Coastal Access Modification Report GAL-MR1

Proposed changes to the submitted England Coast Path proposals
for Gretna to Allonby

Location affected: **Burgh Marsh/Burgh-by-Sands, Cumbria**

9th May 2022

Map GAL-MR1d - Key Statutory Environmental Designations

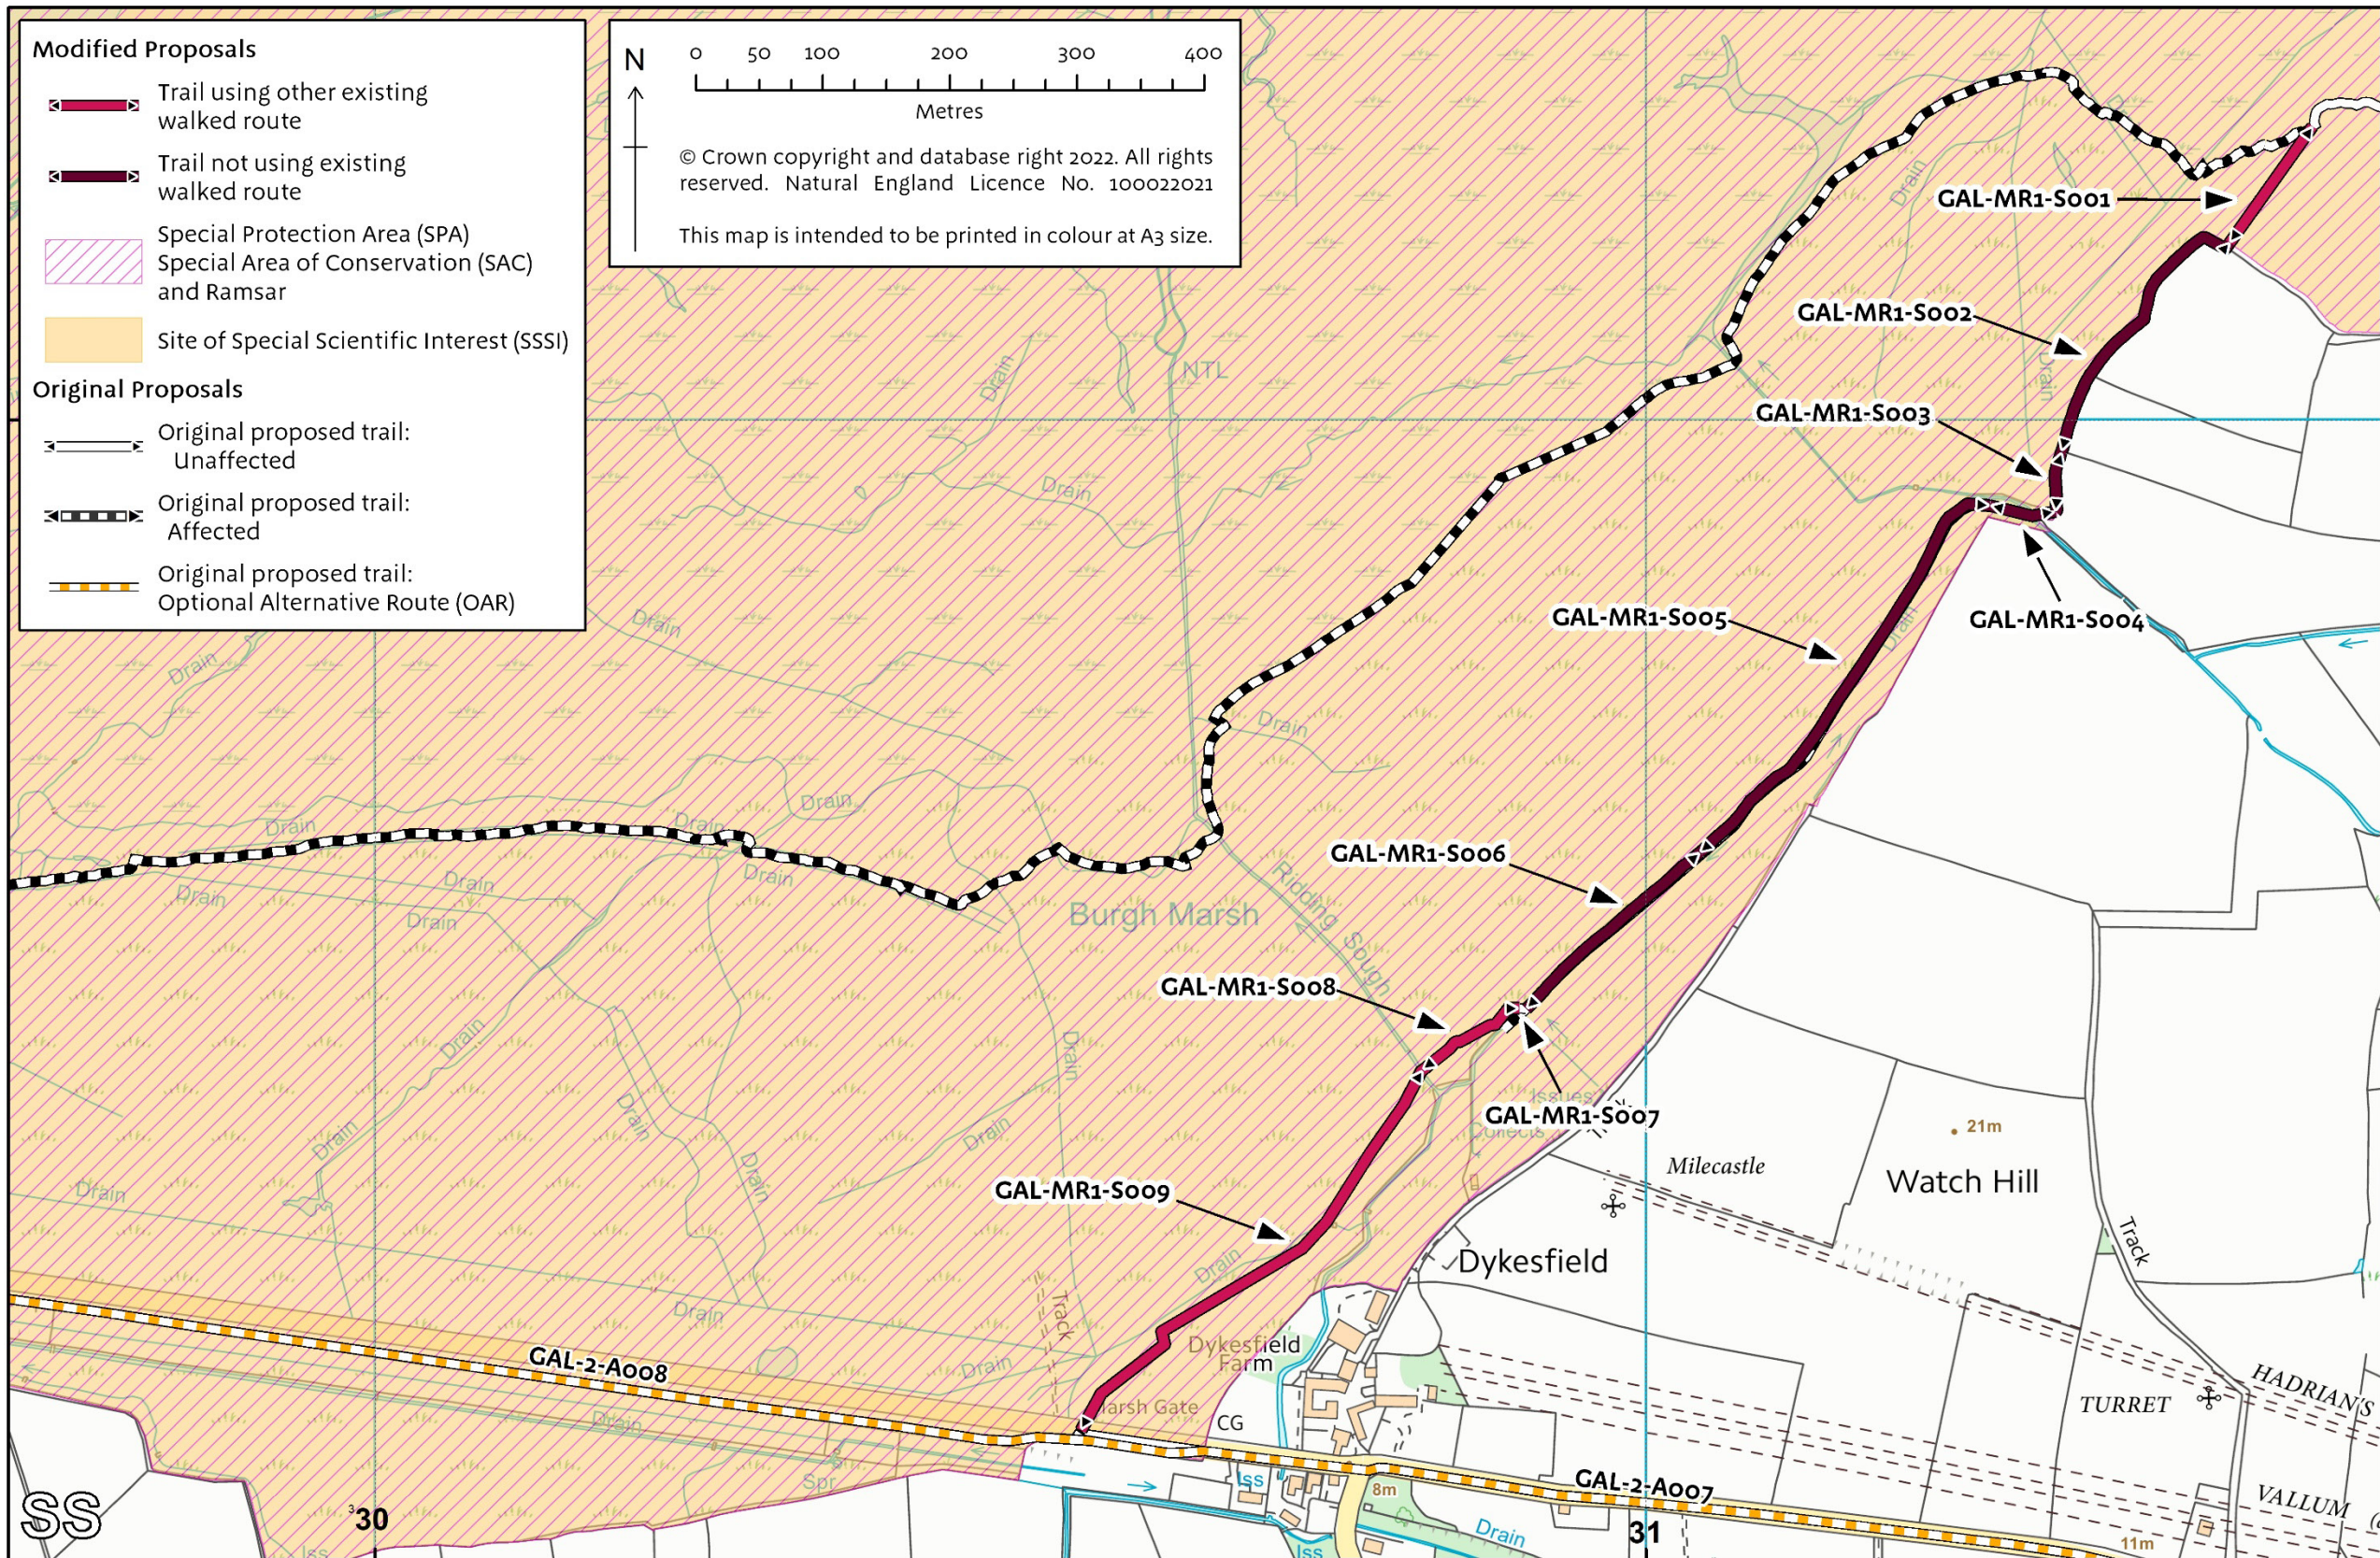
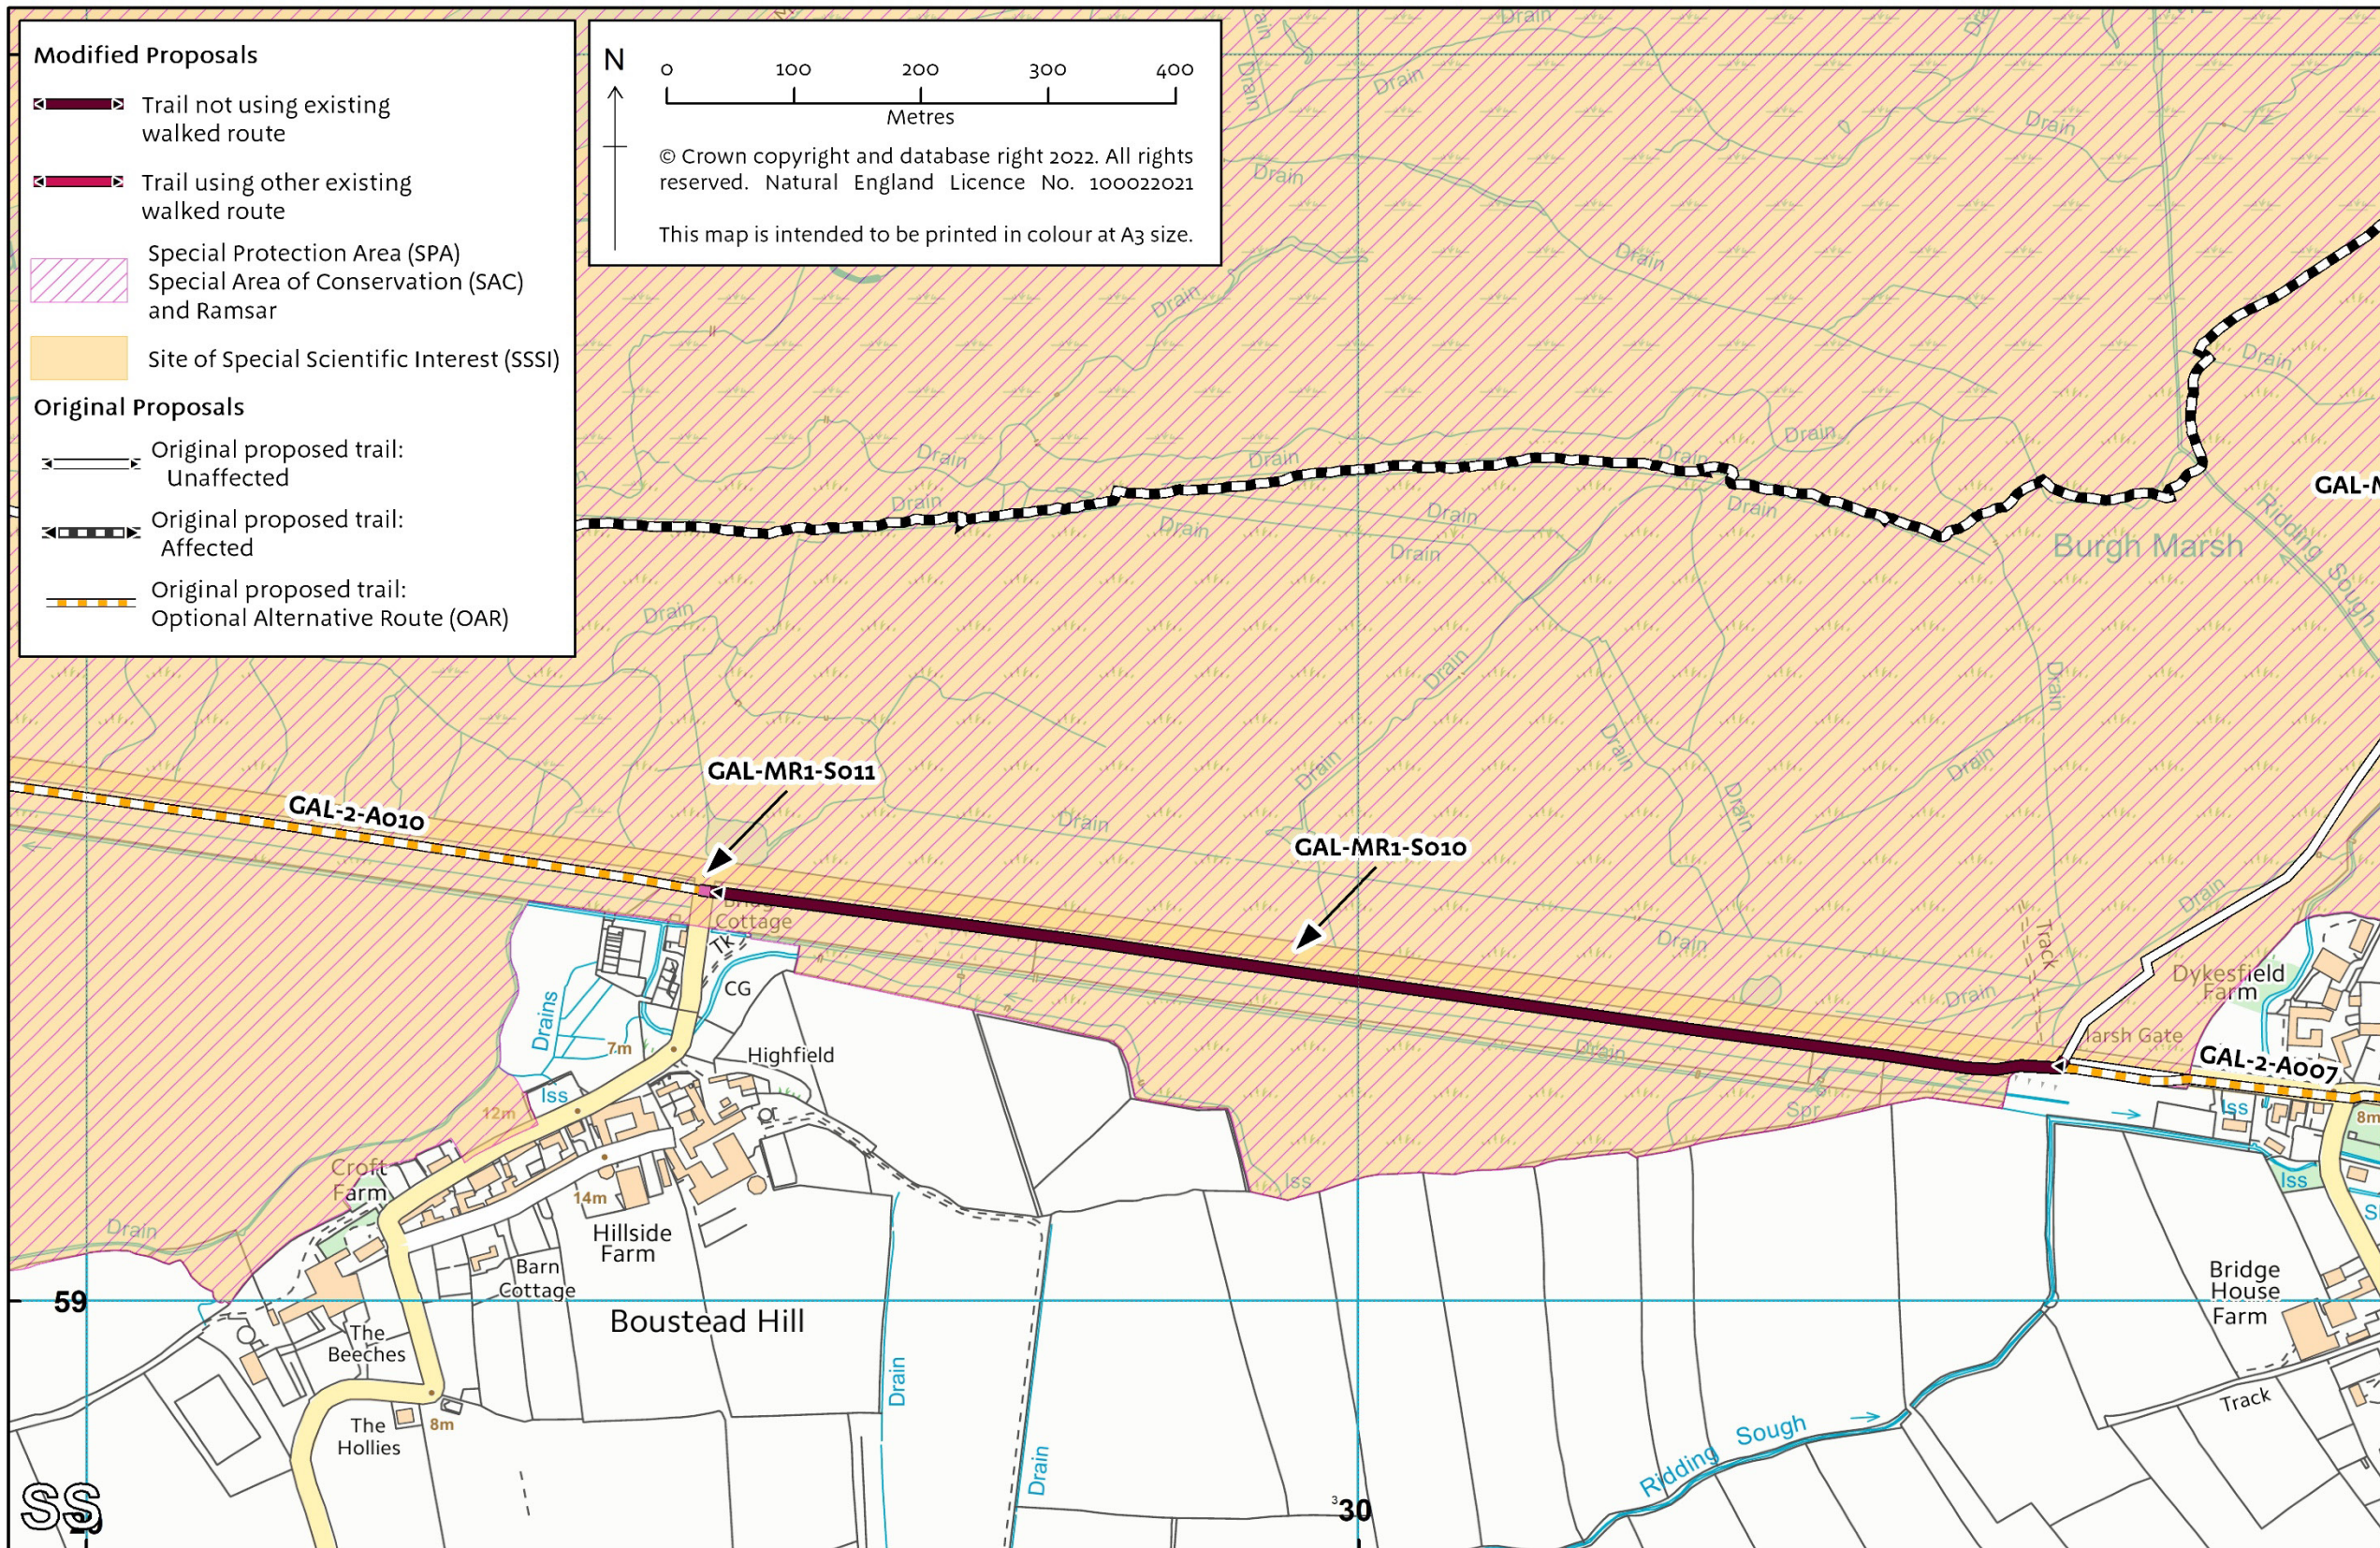
Refer to 'Key Statutory Environmental Designations' maps below – MR1d/1e/1f

A.2.5 The trail passes through saltmarsh habitat, which is a feature of the SAC/SSSI. This habitat can be sensitive to trampling damage. The modified proposals would reduce the amount of trail through this saltmarsh by approximately 1.9km, compared with the previously published proposals. The route has been designed to minimize the impact on the saltmarsh habitat by aligning on existing embankments or paths wherever possible. Small sleeper bridges (rather than culverts & path surfacing) would be installed in wet areas to minimize permanent loss of habitat and so that the route will not impact on the hydrology of the site. The area through which much of the modified trail would be aligned is predominantly grazing marsh, rather than true saltmarsh. The vegetation is robust and will withstand an increase in footfall.

A.2.6 Burgh Marsh is used by breeding and non-breeding birds, which are features of the SPA and Ramsar sites, and could be disturbed by walkers and dogs. The route has been designed to avoid areas frequently used by these features. Much of the modified route would be within a fenced corridor (for land management reasons); this will also reduce the risk of disturbance to any birds that are using the areas near the trail. The fencing will be maintained by the landowner. We have updated the HRA to include the modification.
